City of Burlingame

Meeting Minutes Planning Commission

- e. 1499 Bayshore Highway/825 Mahler Road, zoned I-I - Application for Commercial Design Review, Special Permits for building height and development under Tier 3 for a new 8-story research and development building with a 7-story parking structure. (King 1499 Bayshore Owner LLC, applicant and property owner; DGA, Inc. architect) (58 noticed) Staff Contact: Catherine Keylon

RE: City of Burlingame – Planning Review

Mills Creek Public Trail

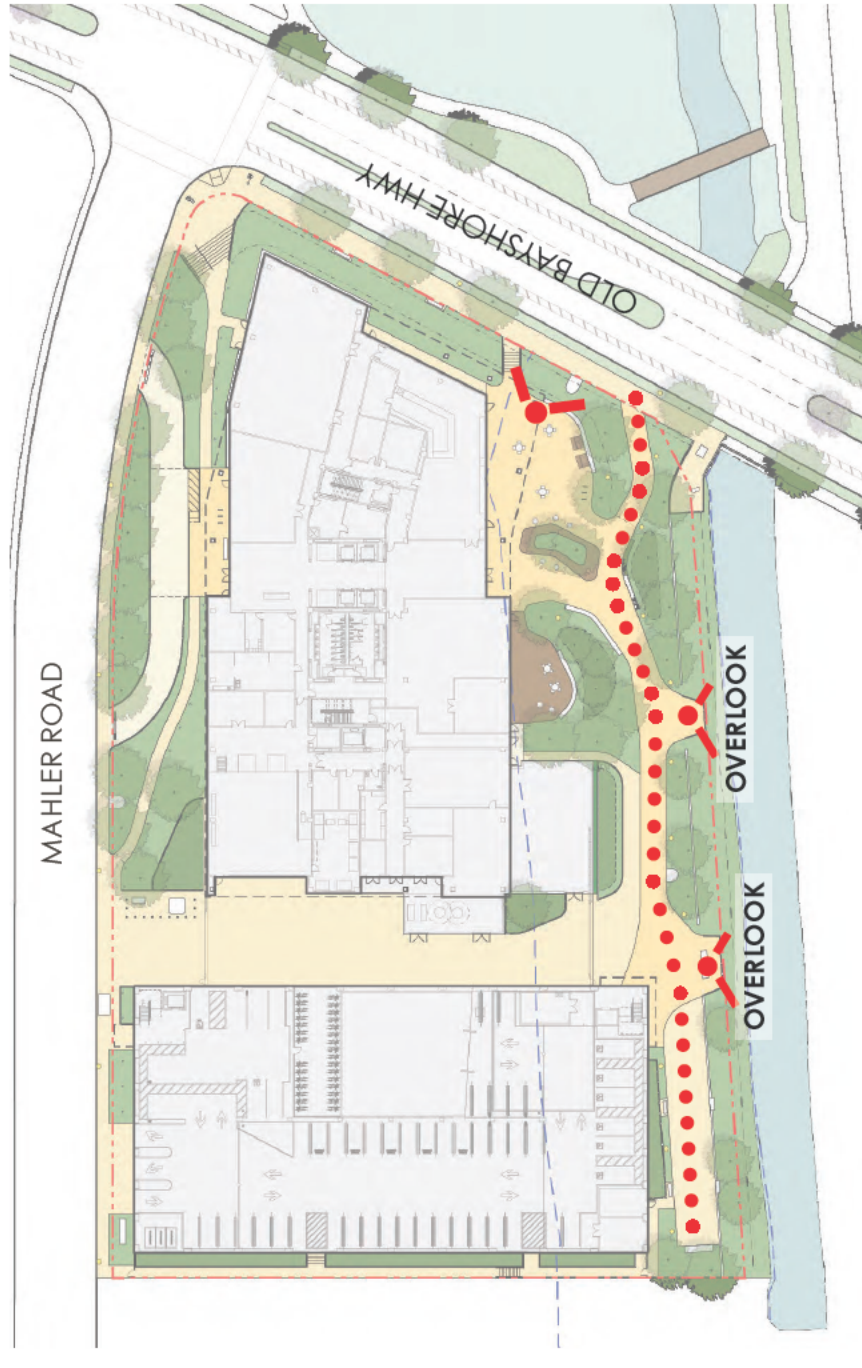
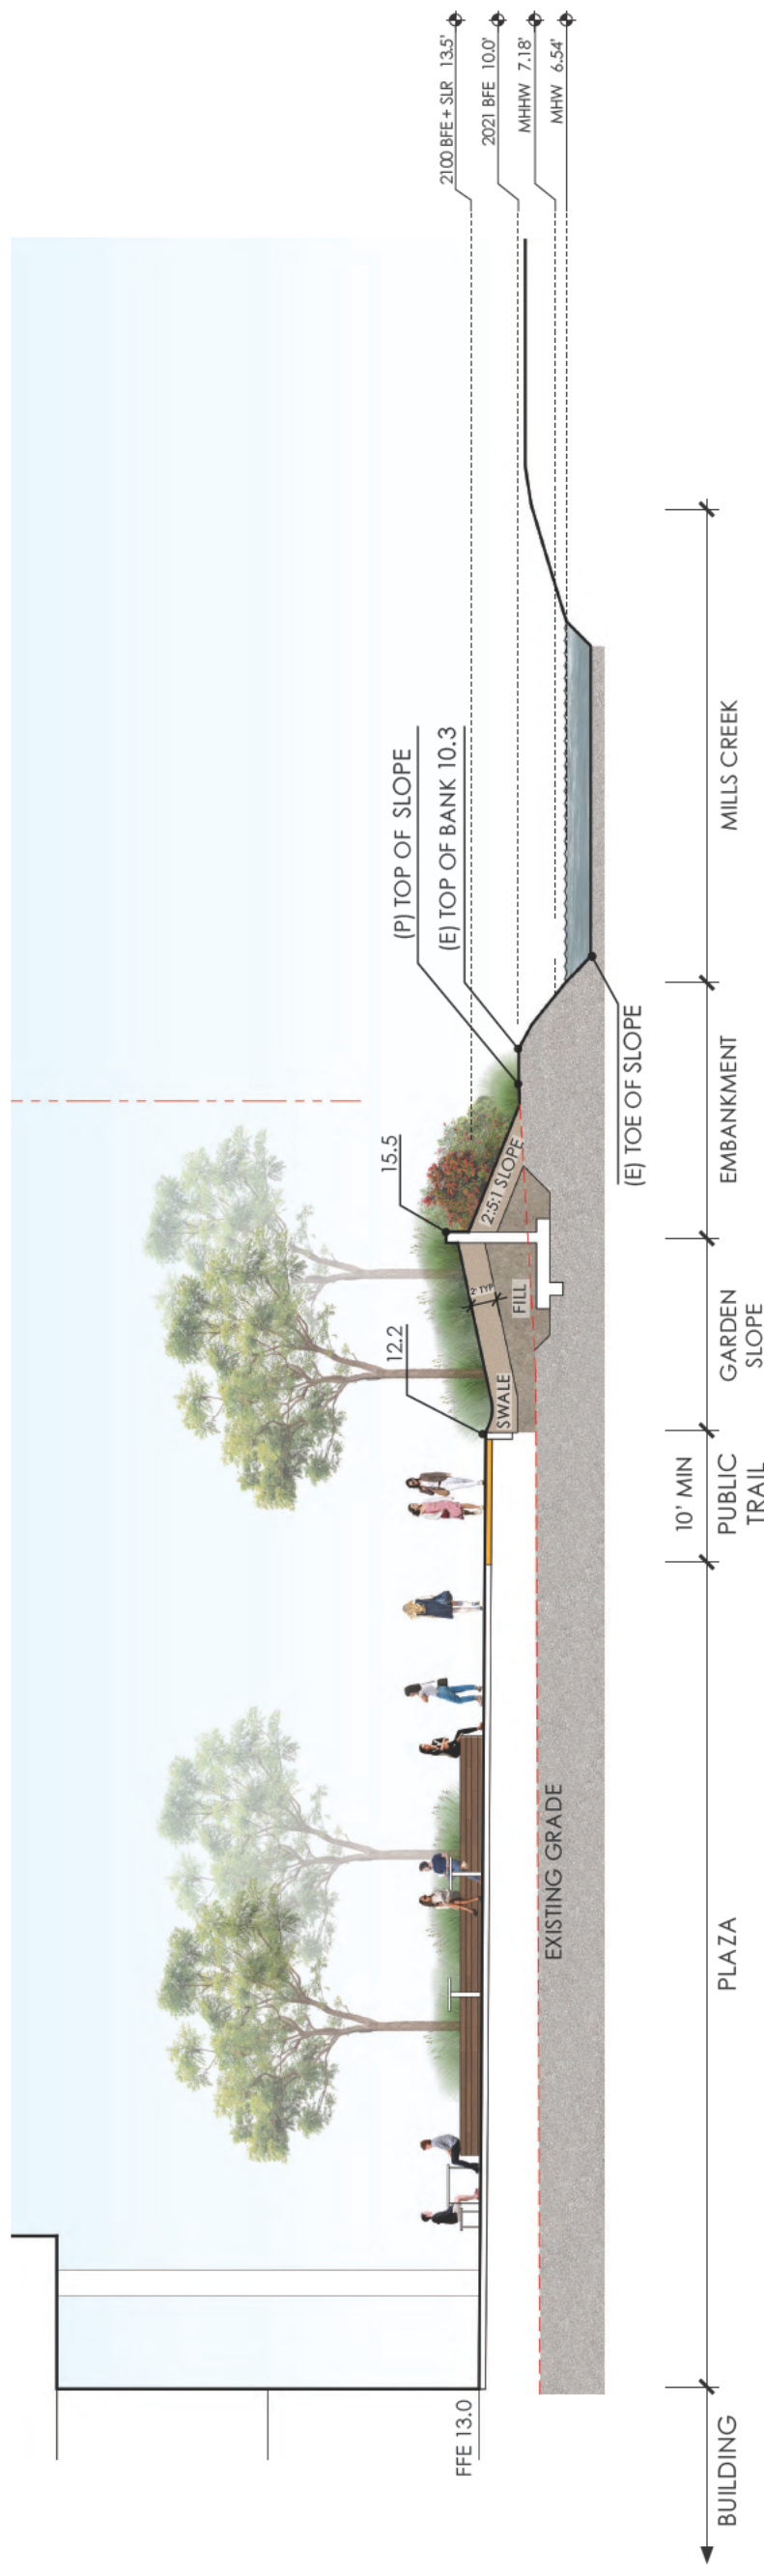
> Public comment sent via email by Athan Rebelos: I noticed that page 30, figure 8 of the plans includes "Mills Creek Public Trail & Overlook". I am delighted to see this in the plans. I would like to be assured that, at a minimum, it will be included as a condition and completed as presented. I would ask to consider in the development of the "Mills Creek Public Trail and Overlook" the potential for a future pedestrian and bike trail along the creek, perhaps passing under the 101 freeway, connecting Rollins Road to the Shorebird Sanctuary, directly across the road from 1499 Bayshore. I also would like to see an obvious pedestrian and bike transition between the "Mills Creek Public Trail", the building's plaza, and the shorebird sanctuary across Bayshore. Landscaping, traffic calming (on Bayshore between the plaza and the sanctuary), pedestrian lighting, decorative crosswalks, and signage are some enhancements that come to mind. Last, prominent public art should be a condition, not an option.

2. Public comment sent via email by Athan Rebelos: I noticed that page 30, figure 8 of the plans includes "Mills Creek Public Trail & Overlook". I am delighted to see this in the plans. I would like to be assured that, at a minimum, it will be included as a condition and completed as presented. I would ask to consider in the development of the "Mills Creek Public Trail and Overlook" the potential for a future pedestrian and bike trail along the creek, perhaps passing under the 101 freeway, connecting Rollins Road to the Shorebird Sanctuary, directly across the road from 1499 Bayshore. I also would like to see an obvious pedestrian and bike transition between the "Mills Creek Public Trail", the building's plaza, and the shorebird sanctuary across Bayshore. Landscaping, traffic calming (on Bayshore between the plaza and the sanctuary), pedestrian lighting, decorative crosswalks, and signage are some enhancements that come to mind. Last, prominent public art should be a condition, not an option.

I noticed that page 30, figure 8 of the plans includes "Mills Creek Public Trail & Overlook". I am delighted to see this in the plans, and I would like to be assured that, at a minimum, it will be included as a condition and completed as presented. I would ask to consider in the development of the "Mills Creek Public Trail and Overlook" the potential for a future pedestrian and bike trail along the creek, perhaps passing under the 101, connecting Rollins Road to the Shorebird Sanctuary, directly across the road from 1499 Bayshore.

- *Overlook at Mills Creek Trail Terminus:* Per the recommendation of the BCDC DRB, a 3rd overlook with interpretive programming has been added to the terminus of the new Mills Creek Public Trail at the southwest edge of the site. This design refinement accommodates the emergency vehicle access, while focusing on the public activation, and daily use of the space. The patterning of two paving types along the Mills Creek Public Trail reduces the perceptual scale of emergency vehicle access area, while allowing for required fire access.
